Fort Street Public School Traffic and Transport Response to Submissions

SSD 10340

Prepared by Arup

For School Infrastructure NSW

Figure 1: Proposed Fort Street kerbside controls

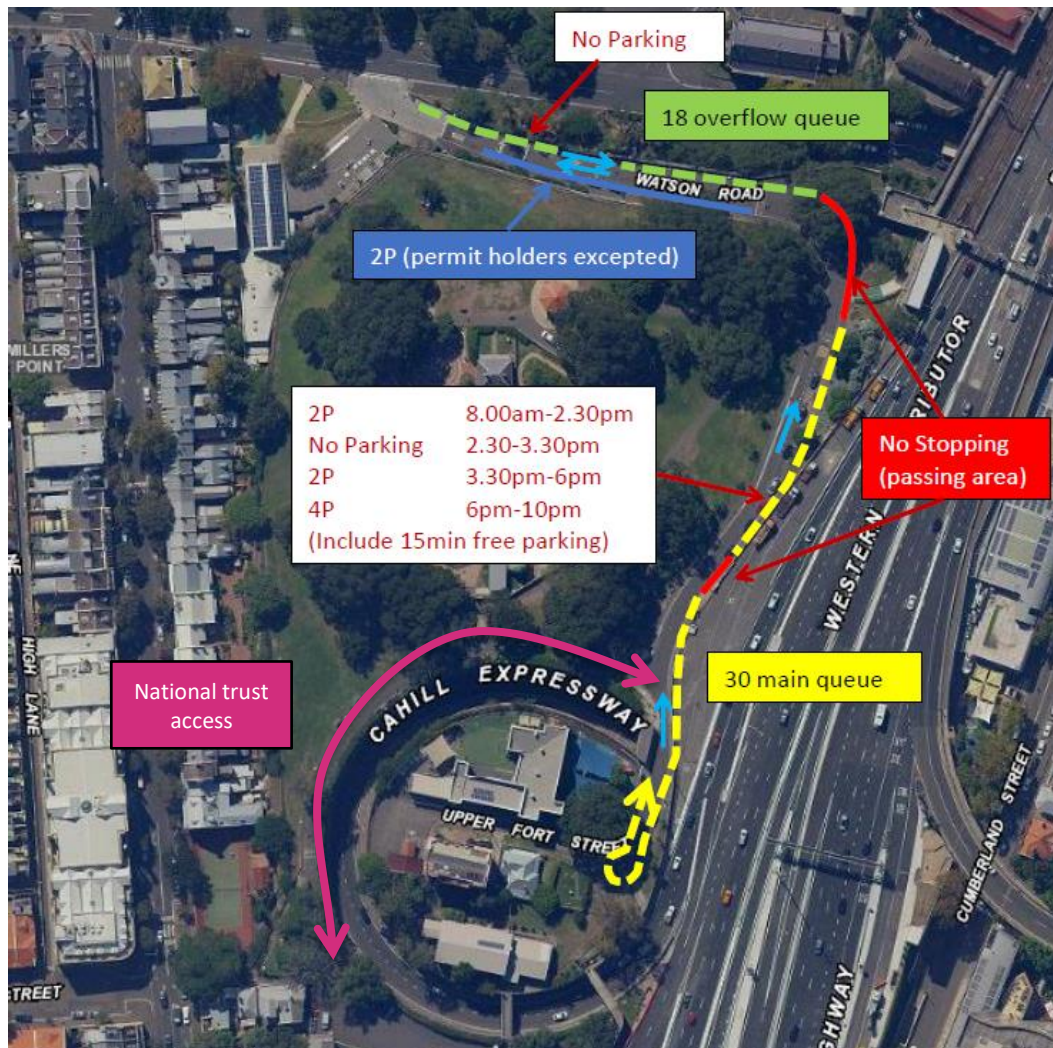
ID	Comment	Response
83	The single-lane private National Trust roadway should not become a shared pedestrian road, as the boom gate at the entrance of the Trust will require drivers to reverse the length of the roadway posing safety risks to children, especially those unaccompanied by an adult.	Noted, no changes are proposed to the National Trust roadway.
84	Several perspective drawings indicate vehicle access to the trust terminating at the eastern end of the current carpark, cutting off an existing road that extends around the Trust Centre to the southern side. The proposed cycleway should not impede this road that provides access to the Trust's loading bay.	Noted, this was a drawing error. The scope of this project does not impact this access road and drawings have been amended.

The access road to the National Trust is not proposed to be modified by the works at Fort Street Public School. Figure 1, shows that this access road is in use and unchanged. The peak queue occurs over concentrated times and moves quickly once DOPU starts therefore National trust access is not likely to be impacted.

Figure 2: Diagram of DOPU operations during phase 1 with existing cycleway

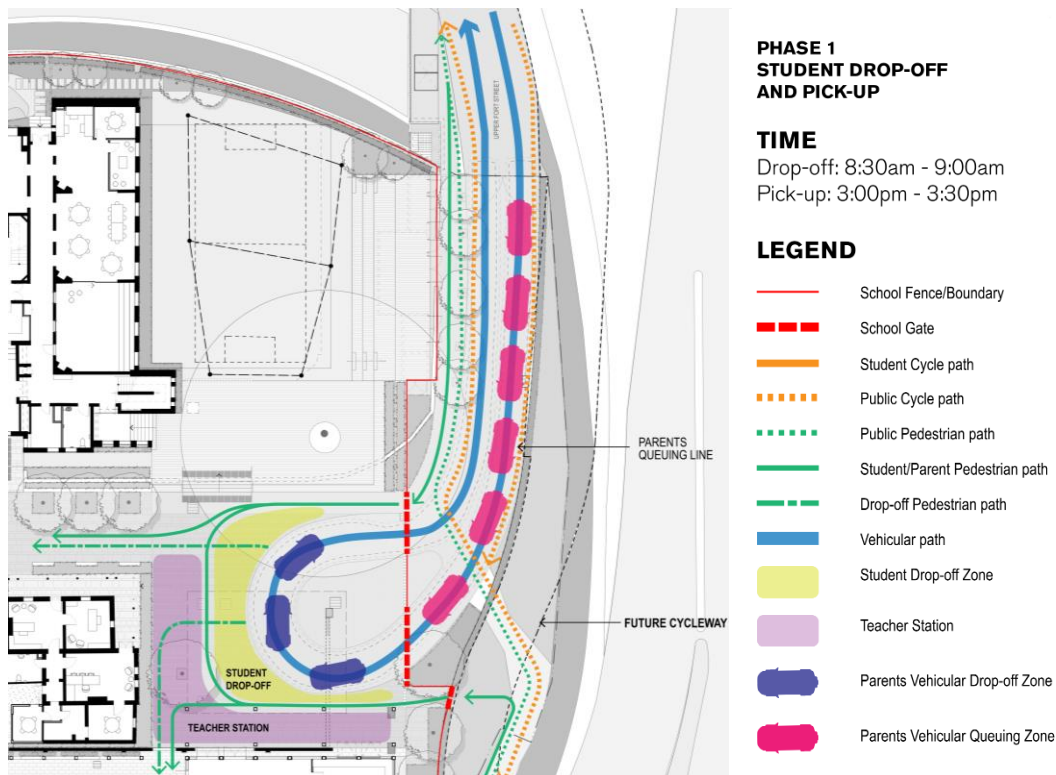
95	<p>Entrance to the school – concerns regarding the safe manoeuvring of vehicles, young children and parents at the pick-up/drop-off zone. Whilst road is being widened, there is only still one entry at the school. Proposed cul-de-sac U-turn arrangement will result in congestion, sight line issues for children using both side doors and rear boots. A linear drop-off/pick-up option is safer and more efficient.</p>	<p>The school is acknowledged to be in a constrained location; however, the arrangement of the cul-de-sac has been successful at other similarly constrained schools such as Lindfield Learning Village. This operation is shown in more detail in Section 3.2.</p>
96	<p>Concerns over queuing down the Argyle Place, management of crossings and intersections along that route, and broader impacts to surrounding streets. This issue also has to be considered in relation to emergency vehicles accessing FSPS during congestion.</p>	<p>The arrangement is designed to limit the likelihood of queuing in Argyle Place by allowing for 48 cars to queue within Upper Fort Street.</p> <p>Emergency vehicle access is possible using the passing points on Upper Fort Street, with lights and sirens operation where the cars stop moving and the vehicle drives onto the other side of the road.</p>

During DOPU hours, there is space for about three large cars to safely complete their DOPU manoeuvres as shown in Figure 2. The area for cars will be delineated through pavement types that is continuous from Upper Fort Street. Staff would stand in this area observing parent's cars and directing students to their parent's cars. Students will marshal in the nearby COLAs while waiting for pickup.

Figure 7: School excursion bus parking

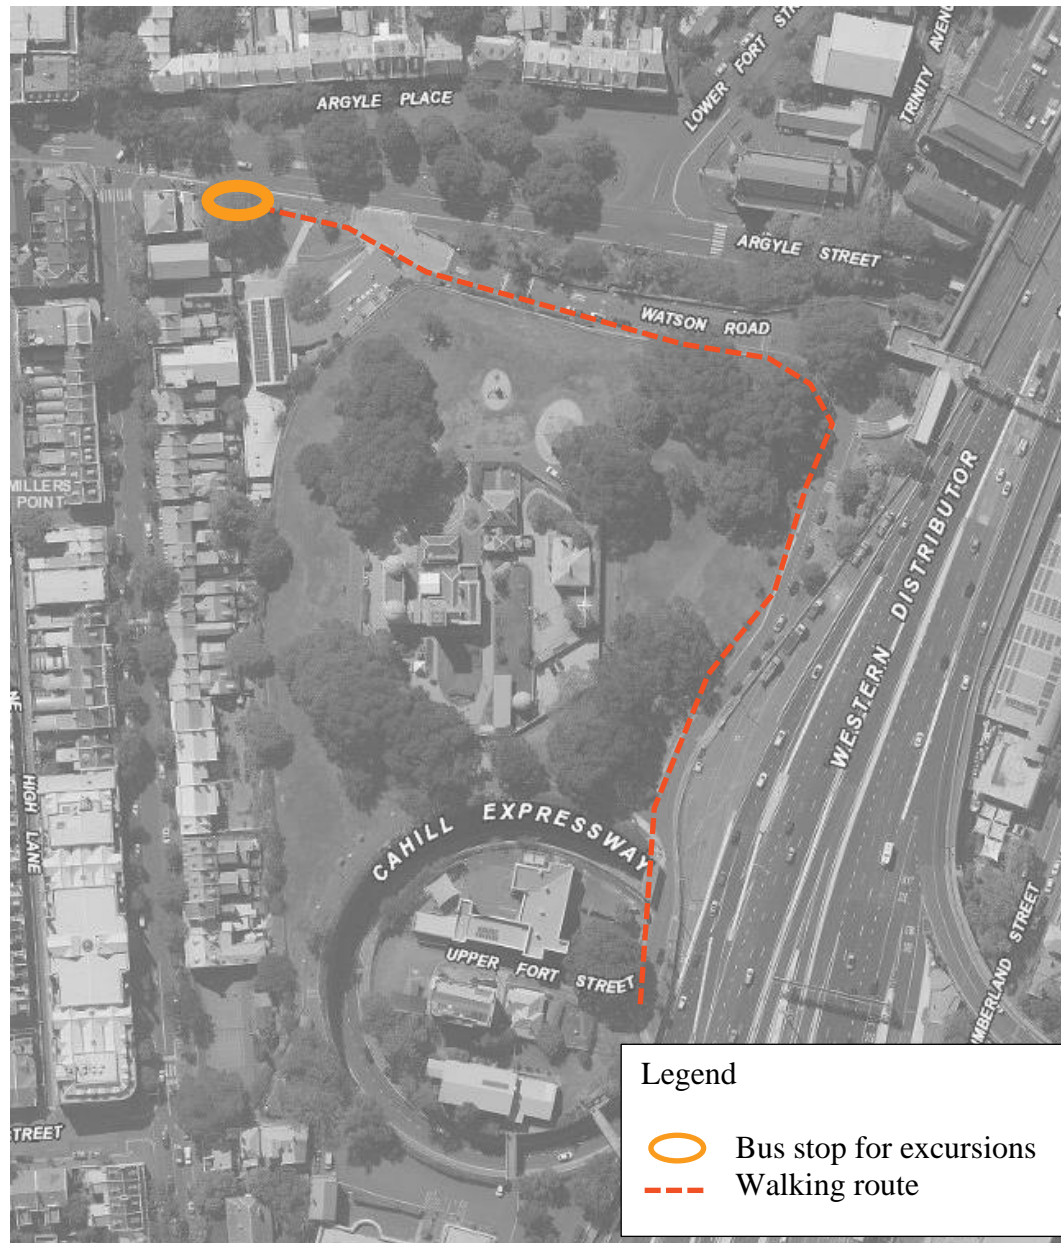
ID	Comment	Response
3	Provide clarification on whether SIDRA included in the TTA addresses the intersection performance after the development at completion and 10 years following that, and the corresponding student numbers at that future point	SIDRA has considered both the immediate and 10-year future term, where the school attendance remains at 550 students, but the existing traffic is uplifted for 10 years of background traffic growth.
3	Provide updated TTA that assesses parking requirements against relevant Council policies and justify any shortfalls.	Parking is not provided on-site. The Sydney LEP 2012 sets out maximum parking rates which are designed to minimise the provision of parking and encourage public transport use. The minimum parking requirement for the site is zero. The proposed development is therefore consistent with Council's controls.
3	Provide clarification on school bus drop-off and pick-up location.	No school buses are proposed for this school. School excursions are re-presented in Section 3.6.

The current arrangement for school excursion bus access will be retained with students being pick-up and dropped off in Argyle Street and using the Watson Road and Upper Fort Street footpaths for access to the school. This is shown in Figure 7.

Figure 9: Indicative truck arrival routes

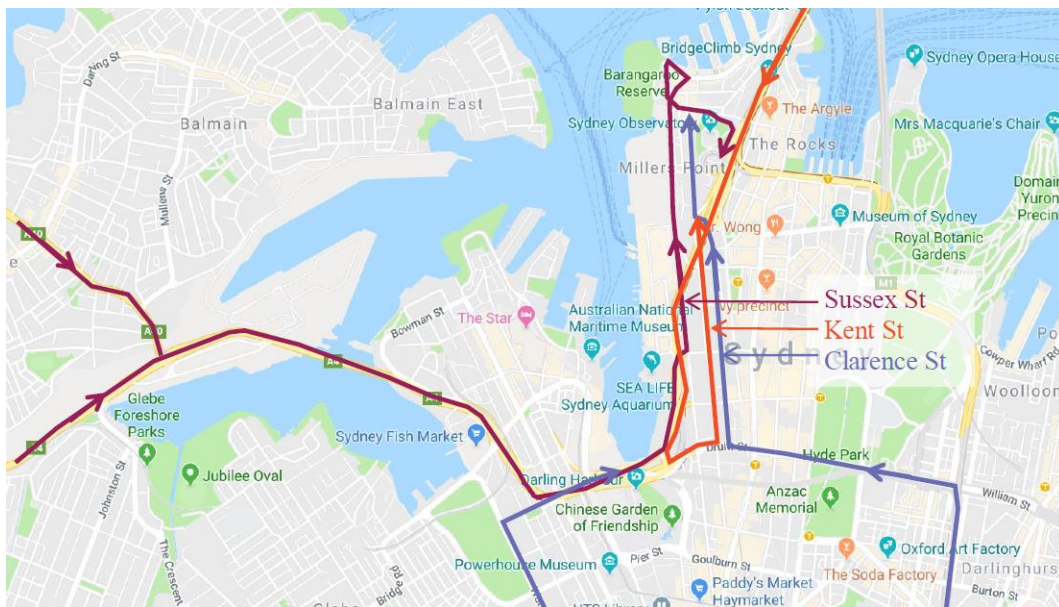
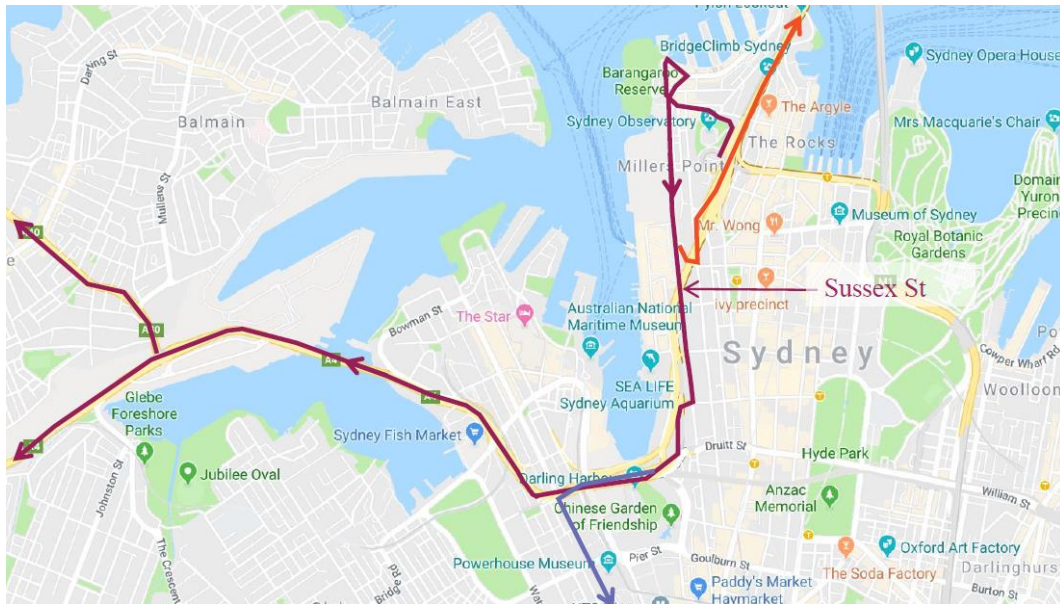
4	Provide updated truck arrival and departure route maps that are legible, details on estimated construction vehicle movements per day and car parking arrangements for construction personnel.	Provided in Section 4.2, which references the construction pedestrian traffic management plan
4	Consider potential construction impacts in the event of concurrent construction of the school and new cycleway.	This is described in more detail in Section 4.3

119	<p>Construction vehicle traffic is a concern as it generates noise, dust and additional traffic. Kent Street should not be used as a point of access/egress for construction vehicles. It is rejected and other options for non-residential streets are available. The contractor should be prohibited in its contract to use Kent Street. The road is narrow and the number of trucks per day will increase risk of accidents causing injury and death. Construction vehicles should use Hickson Road, Argyle Street and Watson Road as their travel route. Heavy vehicle temporary parking is an existing issue and all future heavy vehicles should drive straight to their sites and not be allowed to layover on residential streets.</p>	<p>The construction routes shown are indicative and will be developed by the appointed contractor and approved in consultation with authorities when applying for construction certificate. These are shown in Section 4.2.2 and include both Hickson Road and Kent Street as possible routes.</p>

ID	Comment	Response
L6	<p>Diversion of construction vehicles along a narrow street, such as Kent Street, would markedly increase traffic congestion and noise, dust, and diesel emission pollution for hundreds of residents and businesses, and compromise the safety of road and footpath users. This proposal comes amidst sustained dust and noise pollution from the construction of Barangaroo, particularly for those on the western side of Kent Street, and is unacceptable to the community. The Development Application does not address the serious impacts of increased traffic along this route made up primarily of heavy vehicles.</p>	<p>The construction routes shown are indicative and would be developed by the contractor when applying for construction certificate. These routes are shown in Section 4.2.2 and include both Hickson Road and Kent Street as possible routes. Truck sizing and programmes will be determined with authorities.</p>

Possible truck approach and departure routes are shown in Figure 9 and Figure 10. These will be focused on the western side of the Sydney CBD utilising Sussex Street and Kent Street. Further development of suitable routes will occur in consultation with the Sydney Coordination Office as the project planning develops.

Figure 12: Potential cycleway diversion route

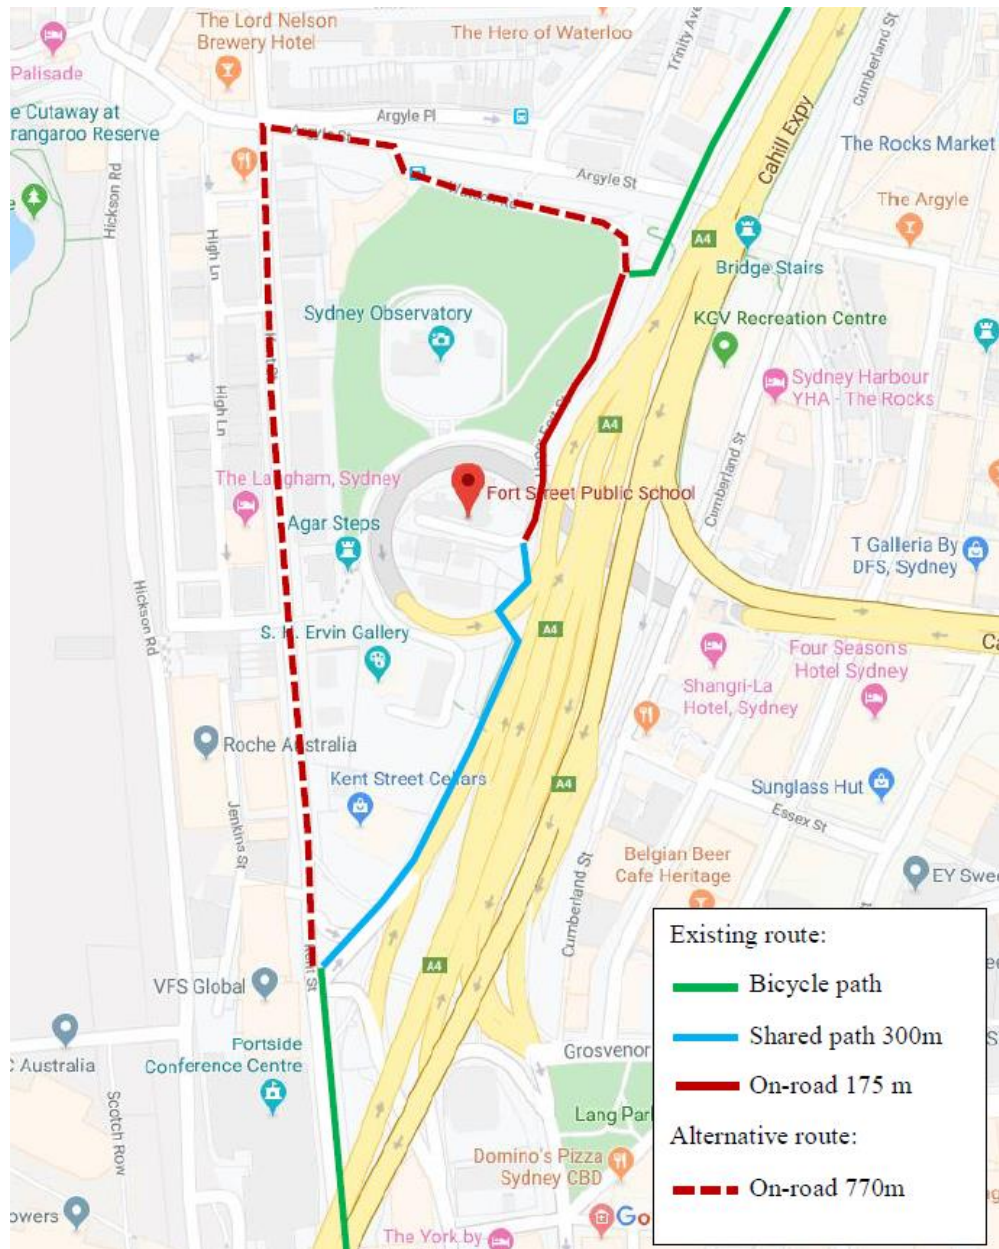
ID	Comment	Response
118	<p>Complete the new cycleway prior to commencement of construction work on the school, per Alex Greenwich MP's letter to Andrew Constance. Kent Street is too narrow with parked cars, has too many crossings and will not be able to accommodate cyclists and construction vehicles. Cyclists will be competing with many types of vehicles and existing users of Watson Rd, Argyle Stand Kent St during peak times. Cyclists are likely to travel too fast, ride too slowly up hills, compete with Taxis doing U-turns on Watson Road, compete with wedding groups, pose safety risks at the Watson Road/Argyle Street intersection, compete with pedestrians using the Kent Street/Argyle St crossing, people walking their dogs.</p> <p>An alternate plan is suggested involving the construction of a new cycle way using the current route, a possible temporary diversion through the tunnel at the top of Watson Rd through to Cumberland St and new parking and speed restrictions for Upper Fort St and Watson Rd.</p>	<p>The SHB cycleway project is outside the scope of the FSPS works and on a different timeline and approval process. However, contingencies for interim operation prior to and during the construction period are shown in Section 3.3.</p>

ID	Comment	Response
127	Safety concerns for people walking to/from work, tourists, residents, children at pick-up/drop-off points and older residents as a result of planned cycleway diversion along Kent Street. Streets will become congested, and bike riders will subsequently move to footpaths causing more safety concerns. Cars exiting Observatory Tower, The Georgia, and Highgate would be unable to see a speeding bike quickly enough to stop. Increased cyclists may also pose risk to Langham Hotel, Fire Station and retail outlets. The diversion will be hard to police and may result in numerous altercations with pedestrians.	The SHB cycleway project is outside the scope of the FSPS works. It is expected that any mitigation as a result of the SHB cycleway project will be undertaken as per a separate process, including all mentioned users.
128	The cycleway must be built before the main work on the school commences, to minimise the duration of the Kent Street diversion.	The SHB cycleway project is outside the scope of the FSPS works and on a separate timeline. The SHB cycleway works program is proposed to be shorter in duration than the FSPS works. See Section 4.3 for more details

The potential cycleway diversion route and facility types are shown in Figure 12. Kent Street is already a shared traffic cycle facility with logos marked in the traffic lane and traffic calming devices along the route.
